Type: Technical Service Bulletin

**Title:** DMTL reposition bracket

**Applicability:** Revero GT and GTS, GS-6 vehicles

**PURPOSE:** A new tank leakage diagnostic module (“DMTL”) bracket is available. This bracket will reposition the DMTL for best performance in the vehicle. Fasteners will be reused, and new hoses indicated in the parts indicated will also be used with the repositioning. (If the bracket has been installed disregard these instructions).

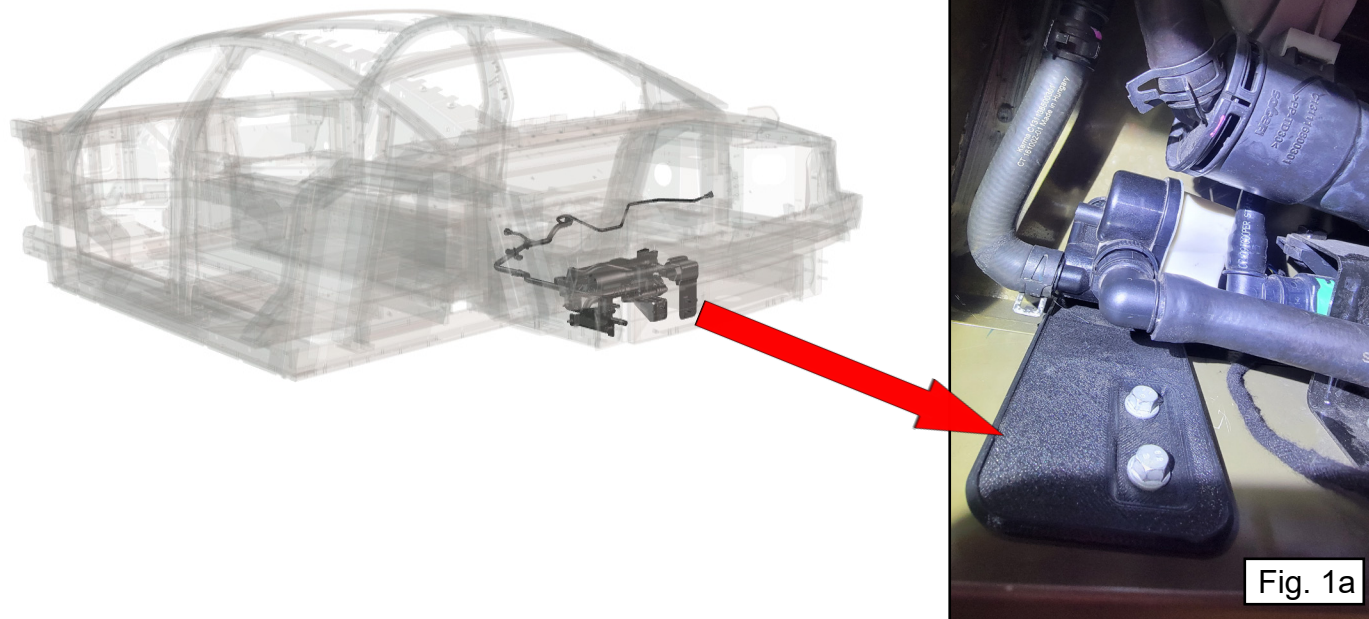
Fig. 1a shows the new DMTL in position with the new bracket (red arrow).

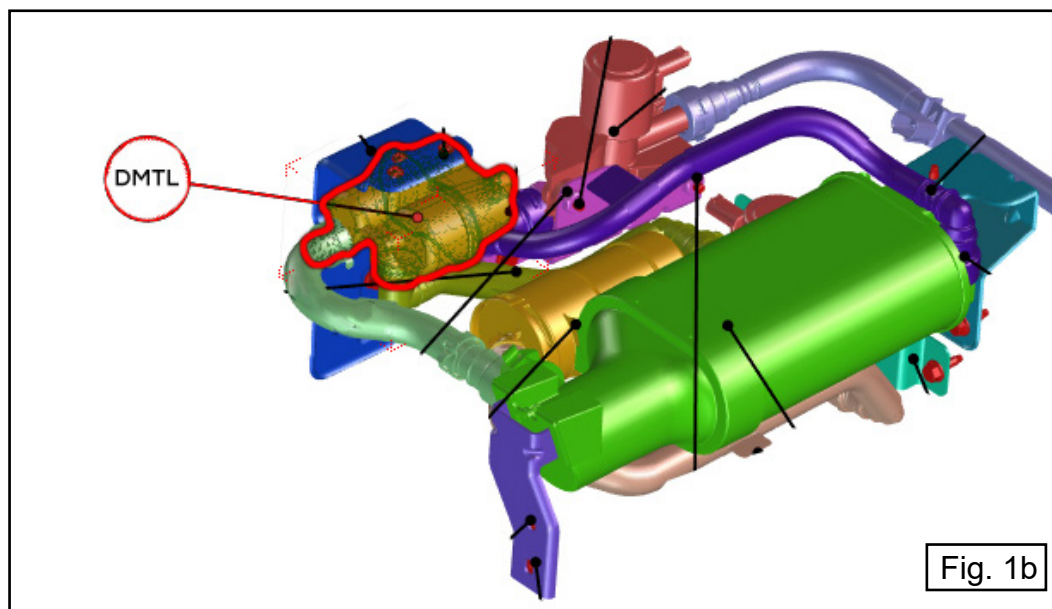
Fig. 1b shows the location and orientation of the DMTL (with new bracket in blue) and hoses .

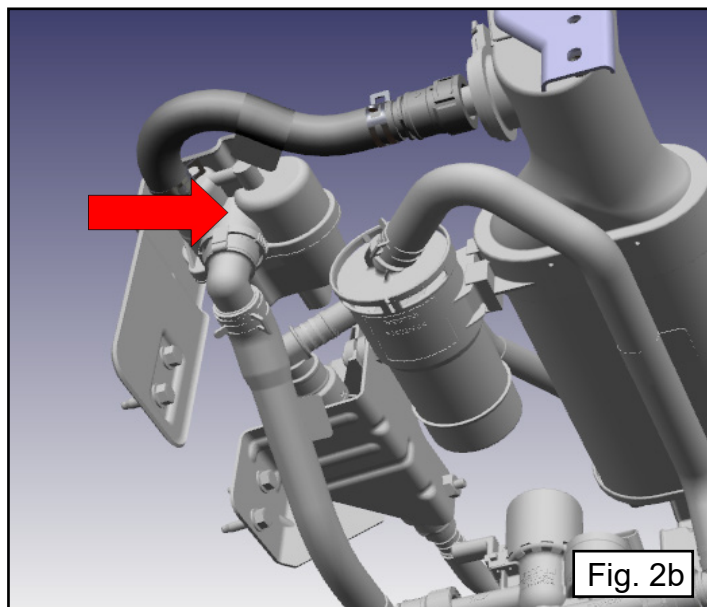
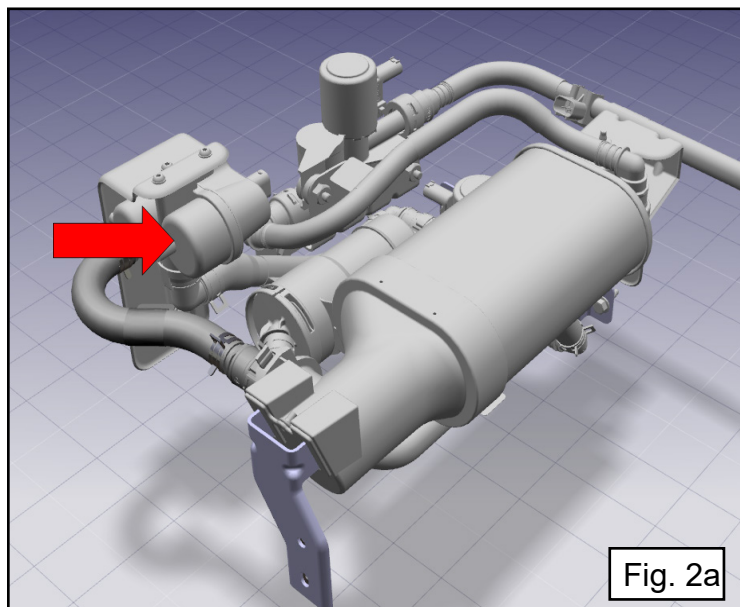
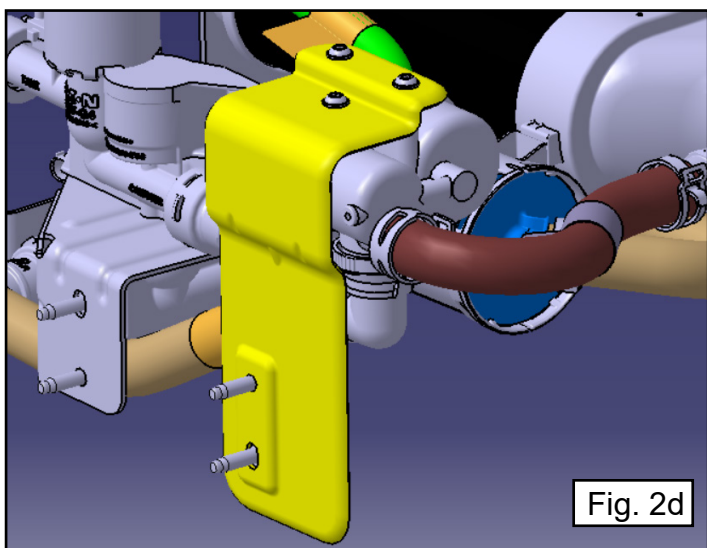
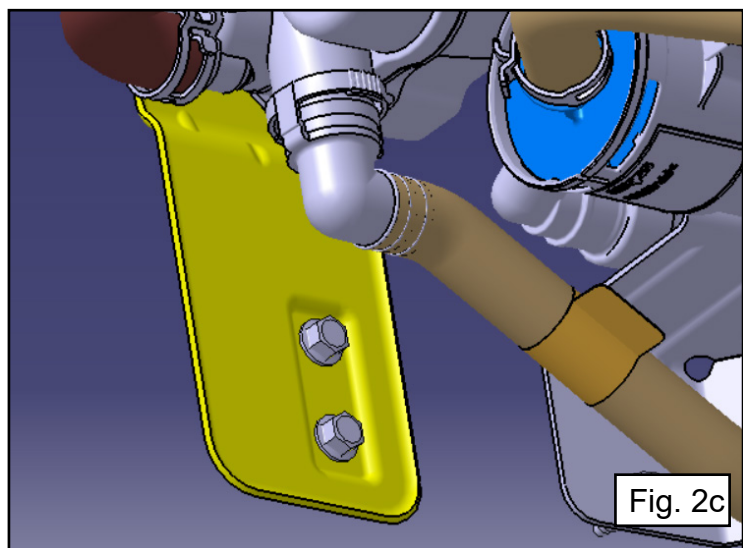
In the figures (Fig. 2a and Fig. 2b) above the DMTL is shown in the correct orientation with the new bracket, and hoses, as indicated with arrows. The new bracket is shown in yellow, and new hoses in brown shown below (Fig. 2c and Fig. 2d).

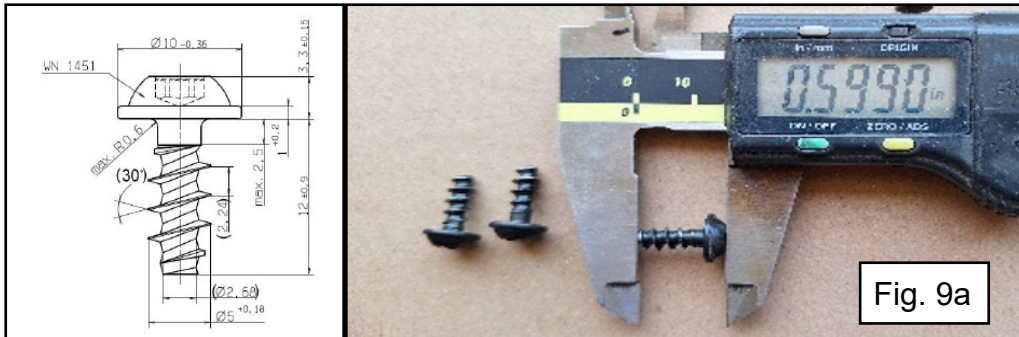
Ensure proper M5x12 screws are used to mount DMTL to bracket. Overlength fasteners can damage the DMTL. If incorrect, contact Parts for C140300307100 SCREW-WASHERHD TORX PT M5x12.

Measure to ensure these are correct length (Fig. 9a).  
15.3mm total length, or 0.6inches, and the thread length is 12mm or 0.47inches.

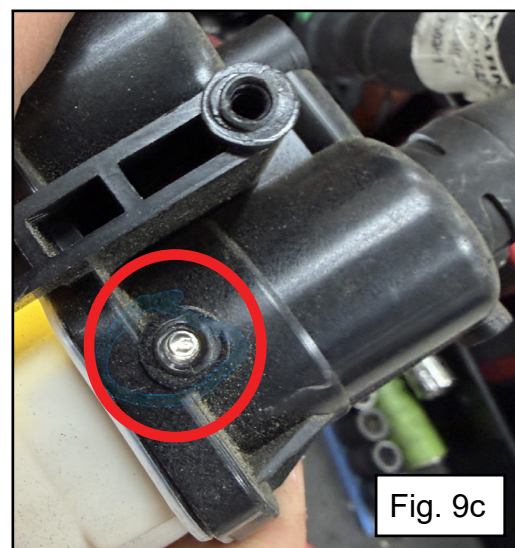
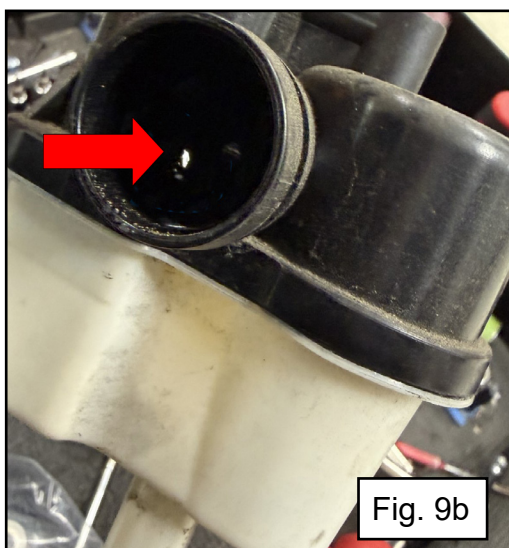
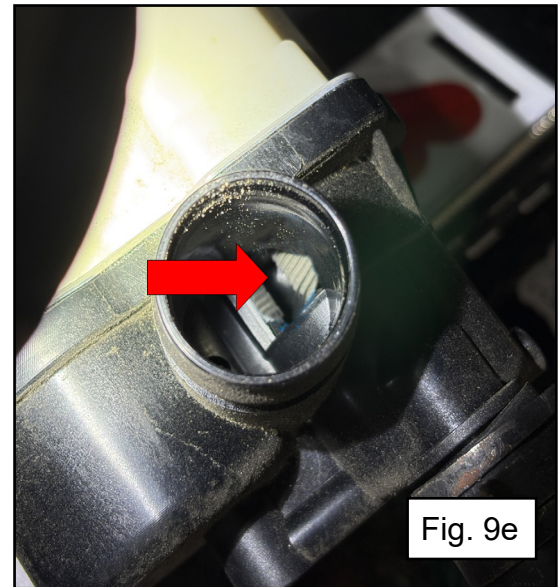
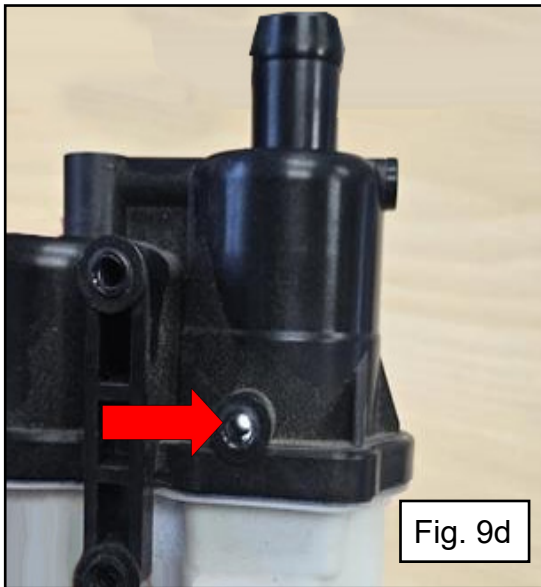
Inspect the DMTL prior to new bracket install. If any damage is found, replace this component with a new one. In this set of images below (Fig 9b,9c, 9d, 9e) light is visible from some damage or a puncture in the material. Replace the DMTL, part number C13116600100, if this condition is found.

Continuing with DMTL inspections (Fig 9d) light is visible in these examples as well, the DMTL should be replaced.

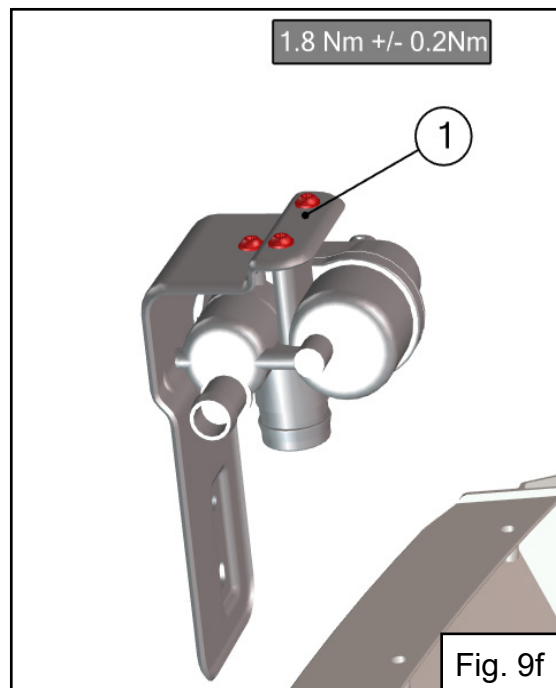
The DMTL is secured to the bracket as shown, assembly torque 1.8Nm +/-0.2Nm, in (Fig.9f).

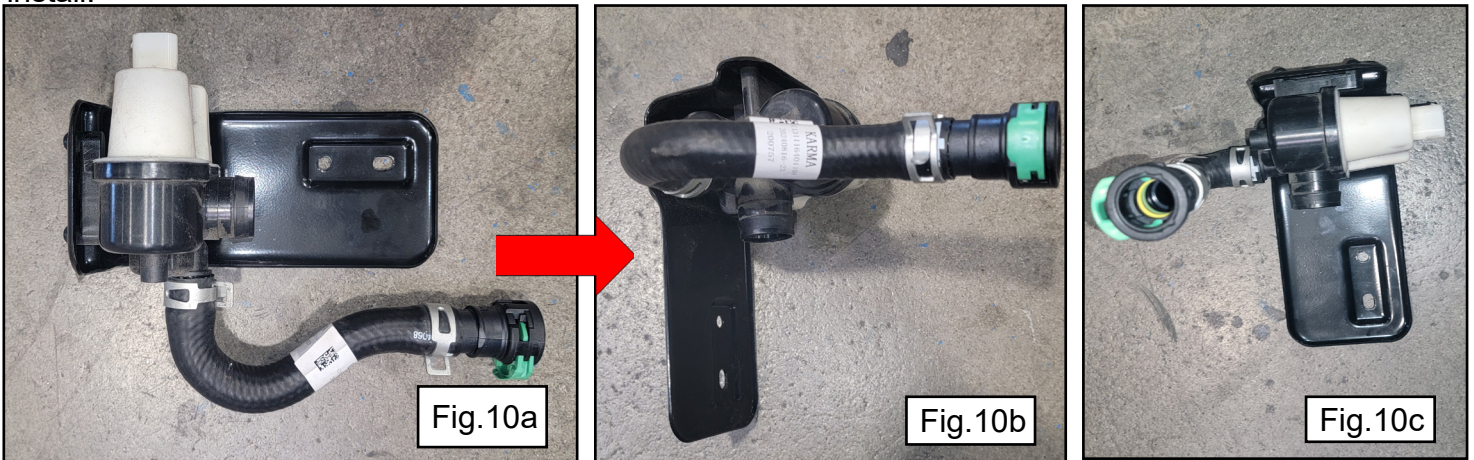
Below is the DMTL with new bracket and hose (Fig. 10a ).

The new hose will need to be rotated ninety degrees (Fig. 10b and Fig.10c ) from original position for install.

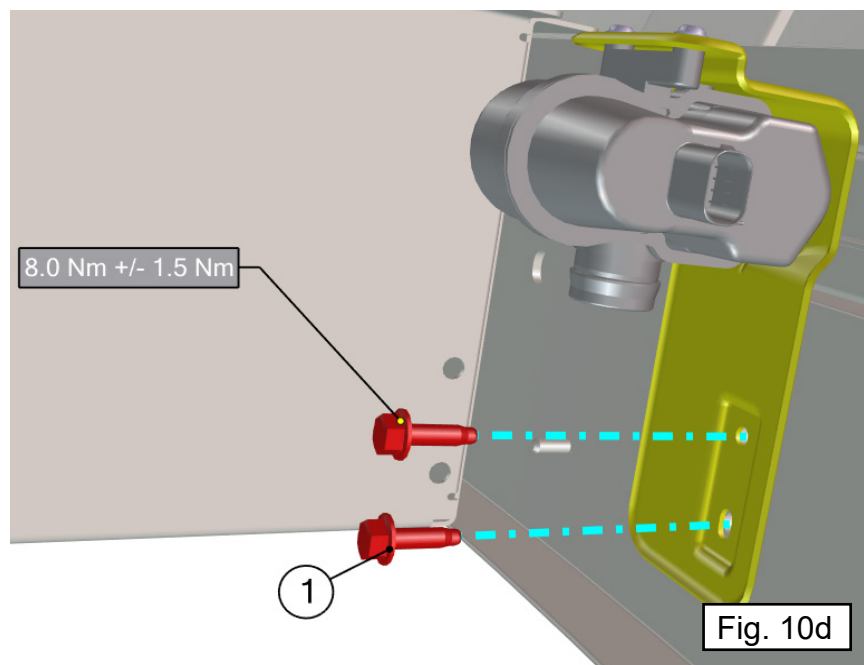
Using the m6 fasteners secure the bracket to the vehicle structure as indicated, torque 8.0 +/- 1.5Nm (Fig. 10d).

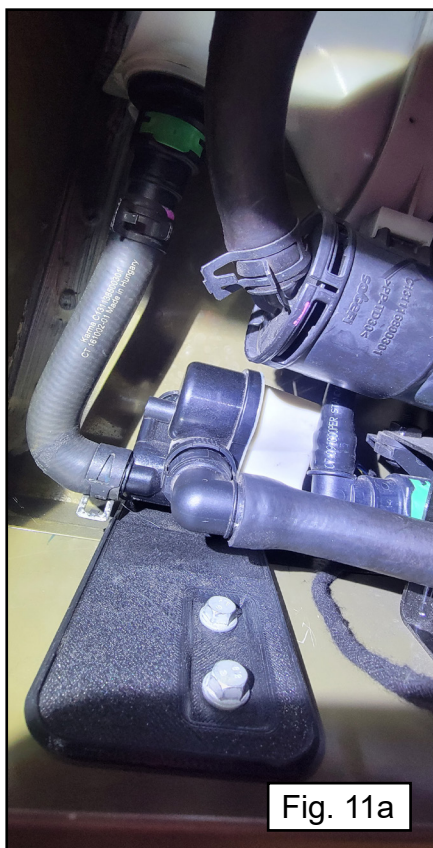
The reinstalled DMTL and the DMTL to FTIV hose assembly (C131116901504) are shown below in (Fig. 11a, Fig. 11b, and Fig. 11c).
